# Work Order ID 100885

# DART SERVICE INSTRUCTION

TO AMEND IIN-D412-704 REV. C OR EARLIER  
AND ICA-D412-704 REV. 4 OR EARLIER  
REF CANADIAN STC SH93-34  
REF FAA STC SR00957NY  
REF EASA STC EASA.IM.R.00696

A	NEW ISSUE (REF PAR)	RF	12.05.07
REV.	DESCRIPTION	BY	DATE
DESIGN	RF	<b>DART AEROSPACE LTD</b>	
DRAWN	RF	HAWKESBURY, ONTARIO, CANADA	
CHECKED		DRAWING NO.	REV. A
MFG. APPR.	N/A	DSI 9611	SHEET 1 OF 2
APPROVED		TITLE	SCALE
DE APPR.		<b>PART NUMBER CORRECTION</b>	
DATE	12.05.07	NTS	
COPYRIGHT © 2012 BY DART AEROSPACE LTD THIS DOCUMENT IS PRIVATE AND CONFIDENTIAL AND IS SUPPLIED ON THE EXPRESS CONDITION THAT IT IS NOT TO BE USED FOR ANY PURPOSE OR COPIED OR COMMUNICATED TO ANY OTHER PERSON WITHOUT WRITTEN PERMISSION FROM DART AEROSPACE LTD.

Figure 5 - Detail L or Figure 25-4 - Detail L

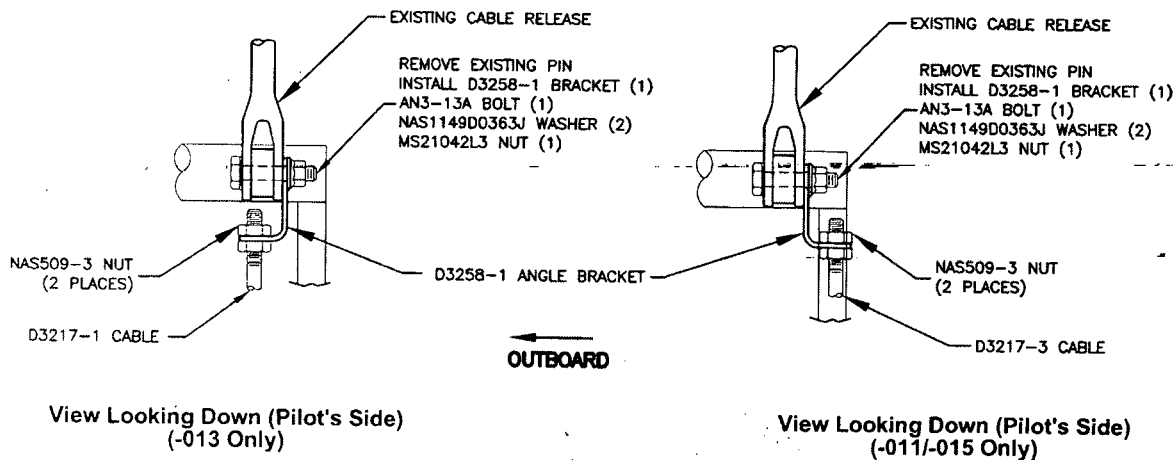
The purpose of this Dart Service Instruction is to correct part number error in Installations Instruction IIN-D412-704 Rev. C or earlier and Instructions for Continued Airworthiness ICA-D412-704 Rev. 4 or earlier. The AN3-13A bolt should be replaced with an AN3-10A bolt in Figure 5 - Detail L in IIN-D412-704 and Figure 25-4 Detail L in ICA-D412-704. See sheet 2.

Revise Detail L Figure 5 of IIN-D412-704 and Detail L Figure 25-4 of ICA-D412-704 as follows:

Qty -043	Qty -045	Part Number	Description
X		D205-704-043	CABLE ASSEMBLY (205)
	X	D412-704-045	CABLE ASSEMBLY (210/212/214/412)
1	1	AN3-10A	BOLT
